Response to Master Thesis Reviewers' Comments

Title	基于进化算法的蝙蝠机器人控制参数优化				Full Name	安武	
					Student ID	2022280136	
					Discipline/		
					Professional Degree	机械工程	
					Category		
					Supervisor	张云 副研究员	
Reviewer 1	XS-G-012-2024- 024-0 1	Title	副研究员	Doctoral Supervis or or not	No	Review Due Date	2024-05-03
Review	Overall rating: B						
Comment s	Detailed ratings: 选题意义: 优; 综述水平: 良; 新见解: 良; 理论知识: 良; 写作水平: 良						
Reviewer 2	XS-G-012- 2024-024-0 2	Title	副研究员	Doctoral. Supervis or or not	No	Review Due Date	2024-05-06
Review	Overall rating: A						
Comment s	Detailed ratings: 选题意义: 良; 综述水平: 良; 新见解: 良; 理论知识: 良; 写作水平: 良

Figure 4.12 Optimal attack angle and motor power using 20 generation of CMA

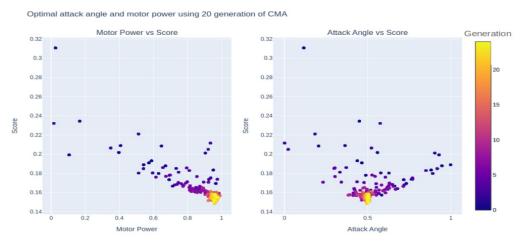
5. 图 4.12-4.14 元素排列复杂,难以解析,建议更改可视化方式;

We now realize that trying to present the results of a 3D plot in a 2D surface has its shortcomings and if possible should be avoided. We have created a completely new way of showing the same information which is much clearer and visually pleasing. Instead of one 3D plot, where we tried to portray the influence the motor power and attack angle had on the score, we made two 2D plots, one for the motor power and the other for the attack angle. The color bar represents the generation of the experiment. In this new plot we can clearly see that the score reduced with each experiment, as the yellow experiments showed consistently the lowest scores. And we could also showed that the results of the 3 different optimization sessions showed the same result, proving the robustness of the results obtained. We would like to remind that the axis have no units, as the values shown are unit-less because this plots

refer to the CMA value, which works on the realm of [0, 1] and is unit agnostic.
